NUCLEAR ENERGY INSTITUTE

SUBJECT: Response to Questions on Addendum 2 to EPRI Performance
Prediction Methodology Software, Version 2.0

**Responses to NRC Comments on
Addendum 2 to EPRI TR-103237-R2**

Figure 1. Determination of Zero Offsets for Valve #24

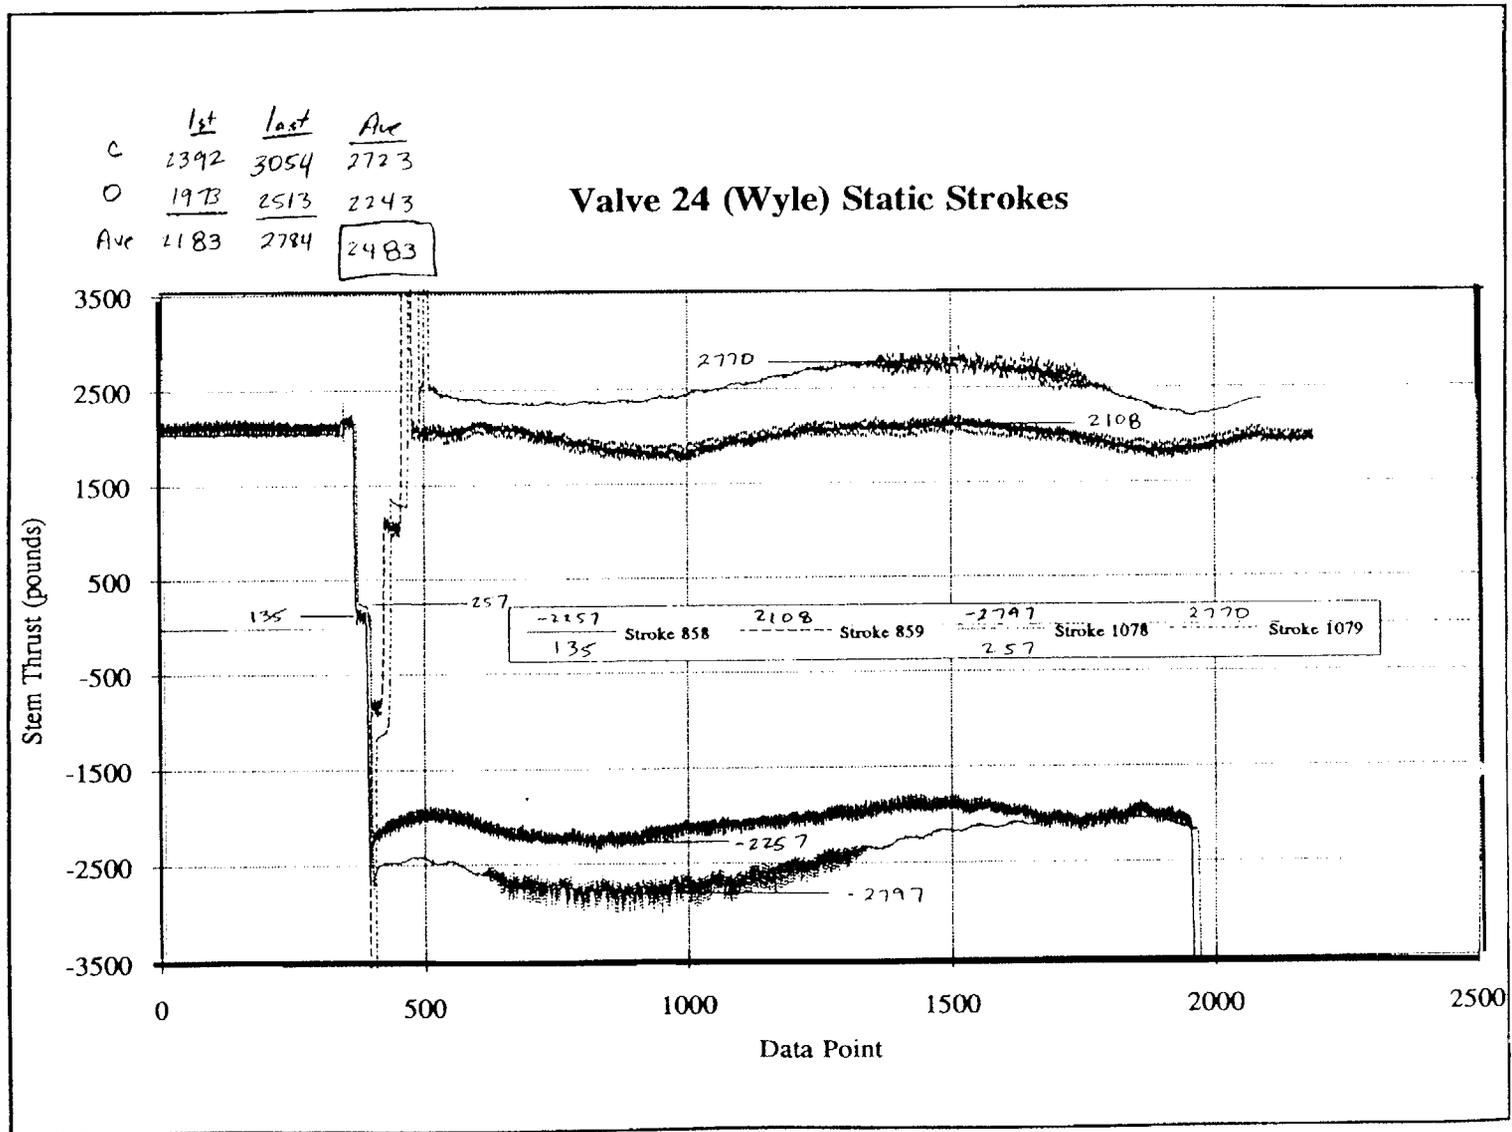
Explain why certain data in Table 1 of Appendix B to EPRI Topical Report TR-103237, Addendum 2, are different from the original test data in previously published EPRI test reports. For example, see the data in EPRI TR-103674-V9P1, "EPRI MOV Performance Prediction Program - High Pressure Cold and Hot Water Blowdown Facility Test Report, Volume 9, Part 1: Test Results for MOV #24."

We assume this comment refers to the term F_{measured} (maximum measured stem thrust) listed in Table 1 of Appendix B of TR-103237-R2, Addendum 2. Values in Table 1 are taken from EPRI TR-103229 and MPR Calculation 140-078-TW14 for solid and flexible wedge gate valves. These values may differ from values presented in the Wyle flow loop test reports (e.g., EPRI TR-103674-V9P1) because of adjustments to account for zero offsets in the data. During the EPRI MOV Program, we performed a detailed analysis of the static test data for each valve to determine if there were zero offsets in the data that should be considered when evaluating the data. For some valves, we found that zero offset adjustments were needed. MPR Calculation 140-81-TW2 determines the zero offsets from the static test data, and MPR Calculation 140-078-TW14 applies the zero offset adjustments to the maximum measured thrust for each valve stroke. The Figure 1, taken from MPR Calculation 140-81-TW2, shows the evaluation of static test data for Valve #24 (strokes performed at Wyle, not at Siemens). As shown, the zero offset for the first static closing stroke performed was 135 pounds, and the zero offset for the last static closing stroke was 257 pounds. Accordingly, in MPR Calculation 140-078-TW1, a zero offset adjustment of 196 pounds (the average of 135 and 257) was used for all Valve #24 strokes performed at Wyle. Therefore, values of measured stem thrust listed in TR-103229 and Addendum 2 to TR-103237-R2 for Valve #24 are 196 pounds higher than shown in TR-103674-V9P1.

Figure B-1. Prediction Ratio (PR) versus Allowable Rate-of-Loading (ROL) for Cold Water Strokes

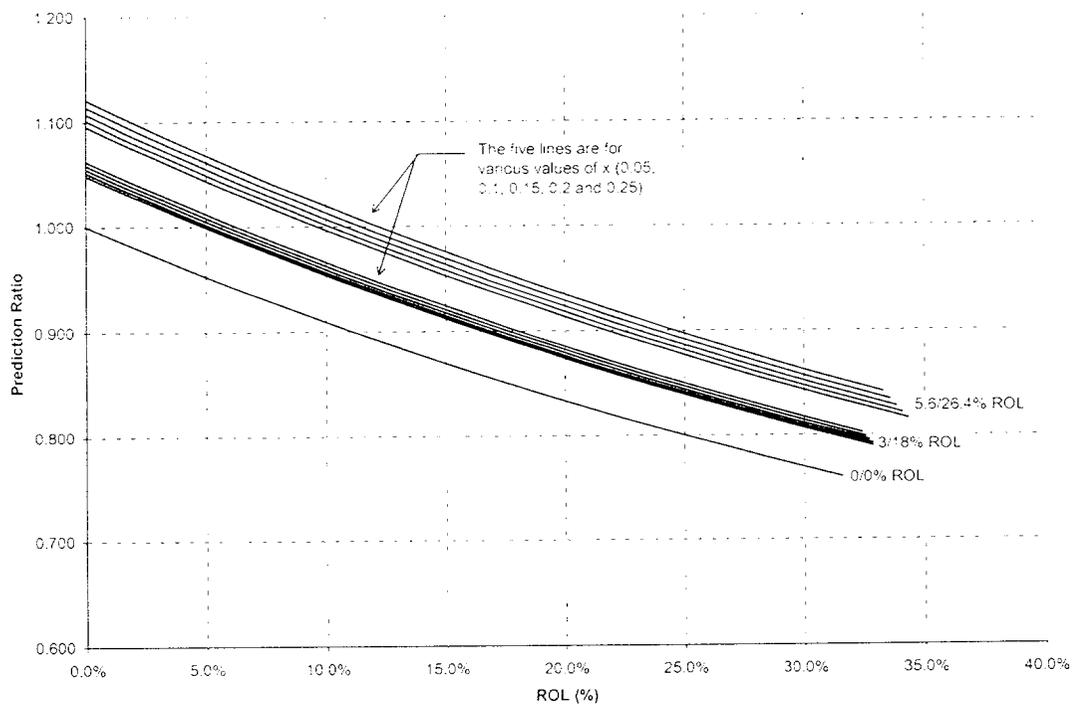
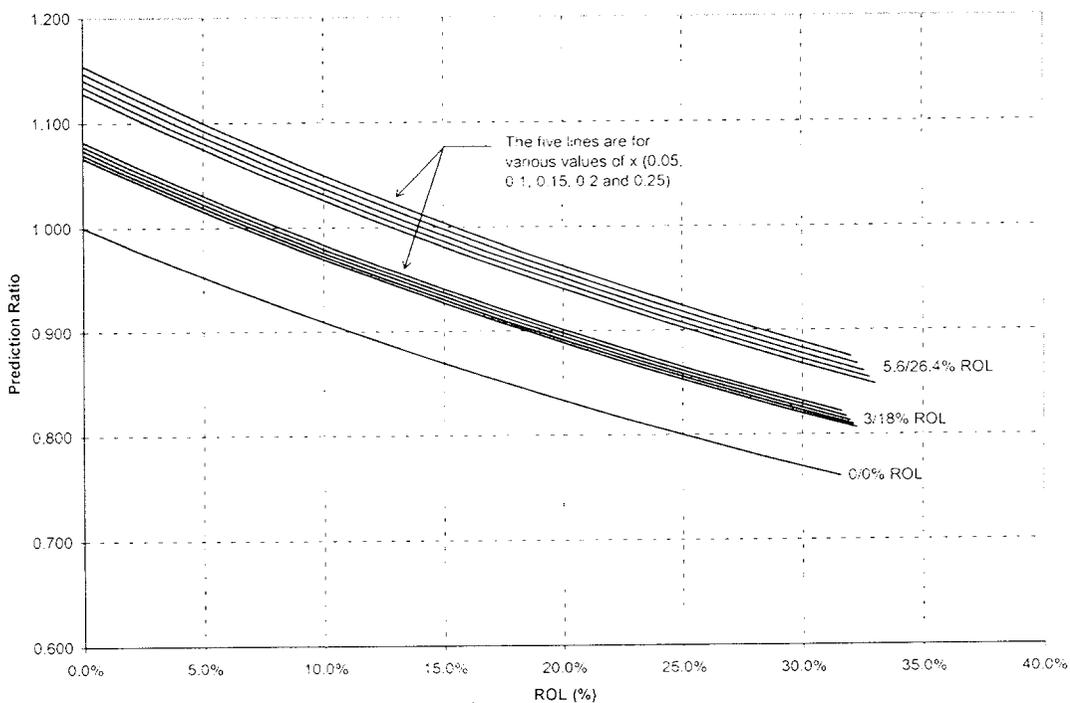
Explain the basis for comparing a prediction ratio based on dynamic thrust predictions from the EPRI MOV PPM to a prediction ratio based on thrust predicted to be delivered at torque switch trip (including random and bias uncertainties) to support the Thrust Uncertainty Method.

Figures B-1 and B-2 plot PR versus available $\text{ROL}_{\text{margin}}$ for ROL values of 5.6/26.4%, 3/18% and 0/0% bias/random, for cold water strokes and hot water strokes, respectively. The five different lines for 5.6/26.4% and 3/18% ROL correspond to x values of 0.05, 0.10, 0.15, 0.20 and 0.25. These plots use the $T_{\text{CST}}/T_{\text{PPM}}$ values shown in the table above. Using the example above, if $x = 0.15$, $\text{ROL} = 5.6/26.4\%$, $\text{APR} = 0.697$ (cold water) and PR is 0.9, the amount of ROL that can be tolerated is 23.1%, as shown on Figure B-1.
